RE: TMDL for Chesapeake(Doc ID EPA-R03-0W-2010-0736-0001, additional comments

Upper Susquehanna Coalition Main Office: 183 Corporate Drive, Owego, NY 13827 607.687.3553

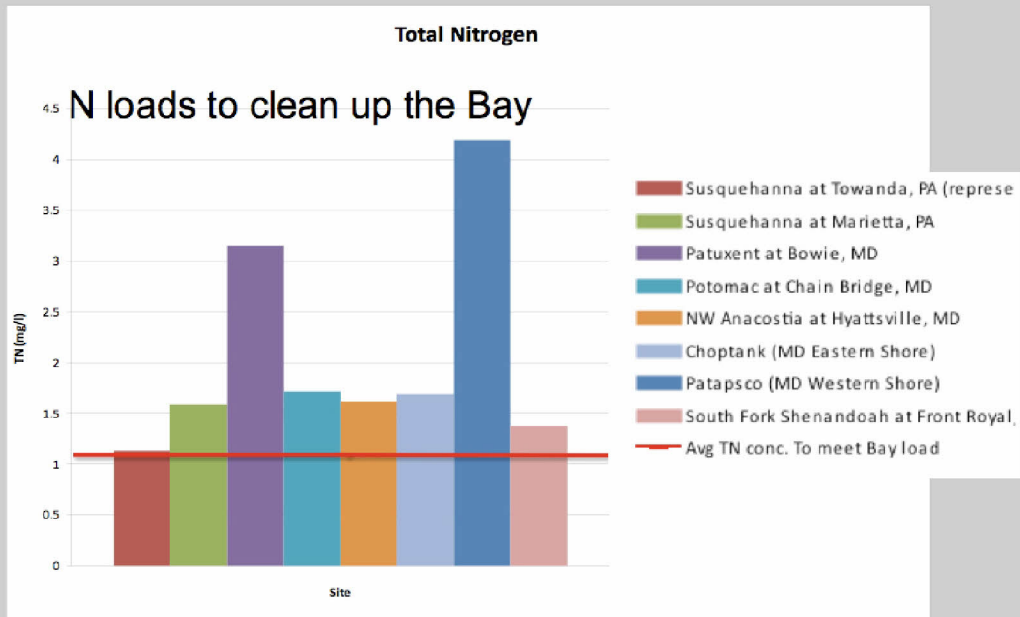
1. Why is it that the TMDL is not based on equal treatment of all sectors? The EPA is forcing all Sewage Treatment Plants to go to “limit of technology”. Why was this same concept not used for the other major source, namely agriculture, where every states agriculture should be reduced to either the limit of technology but at least each states agriculture should be reduced to get same delivered load, not a percent. If all States were required to have similar allowable loads from their various sectors, the states would have to reduce their loads to NY’s level to meet the TMDL (see graph).
